AMENDMENTS TO FIRE CODE 2018 - 9th BATCH OF AMENDMENTS

SCDF would like to issue the 9th batch of amendments to the Code of Practice for Fire Precautions in Buildings 2018 (Fire Code 2018). The amendments which were deliberated and accepted by the Fire Code Review Committee are attached as Annex A & Annex B of this circular.

Annex A

TABLE 4.2C: FIRE ENGINE ACCESSWAY/FIRE ENGINE ACCESS ROAD FOR PG VI & VIII BUILDINGS

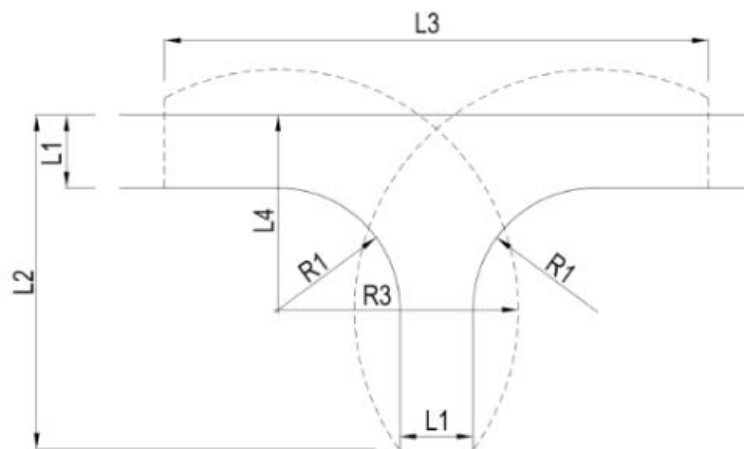
| 34 | <u>Table 4.2C</u> | 01/09/2021 | 01/03/2022 | Revised/ Clarification | Existing <u>Table 4.2C</u> | See <u>Annex B</u> (affected portions of <u>Table 4.2C</u>) |

| Details | Habitable Height (m) | | |
|---|---|----------------------------|------------------------|
| Width of fire engine accessway | ≥ 6m | ≥ 6m | ≥ 7m |
| Type of firefighting appliance | CPL 34 & AL 56 | CPL 34 & AL 56 | AL 56, CPL 60 & HLA 90 |
| Loading capacity of fire engine access road # | ≥ 30 tonnes | ≥ 30 tonnes | ≥ 50 tonnes |
| Loading capacity of fire engine accessway # | ≥ 30 tonnes | ≥ 30 tonnes | ≥ 50 tonnes |
| Turning facility | See <i>Diagram 4.2.2e.</i> <i>under (> 10 & ≤ 50)</i> | See <i>Diagram 4.2.2e.</i> | |

Diagram 4.2.2e. : Turning facilities for firefighting appliances

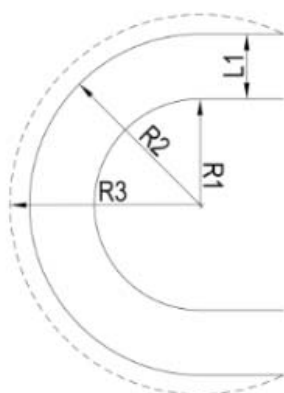
| 35 | Diagram 4.2.2e. | 01/09/2021 | 01/03/2022 | Revised/ Clarification | Existing <u>Diagram 4.2.2e.</u> | See <u>Annex B</u> (affectation portion of <u>Diagram 4.2.2e.</u>) |

| Dimensions of Turning Facilities for Firefighting Appliances | | | |
|--|---------------------------|--|-------------------|
| R1 | 4.0m | 6.5m | 7.5m |
| R2 | 8.0m | 10.5m | 12.0m |
| R3 | 8.5m | 12.0m | 14.8m |
| L1 | 4.0m | 4.0m | 4.5m |
| L2 | 11.0m | 16.0m | 21.0m |
| L3 | 15.0m | 28.1m | 33.5m |
| L4 | 8.0m | 10.5m | 12.0m |

* - These dimensions are applicable to all PG except PG VI and VIII buildings, unless otherwise stated in *Cl.4.2.2a.(1)*. For PG VI and VIII buildings $\leq 10\text{m}$, it shall refer to ($> 10 \ \& \ \leq 50$) requirements (as indicated in *Table 4.2C*).

- Not applicable to PG I buildings. For PG I buildings, it shall refer to ($\leq 10\text{m}$) requirements.
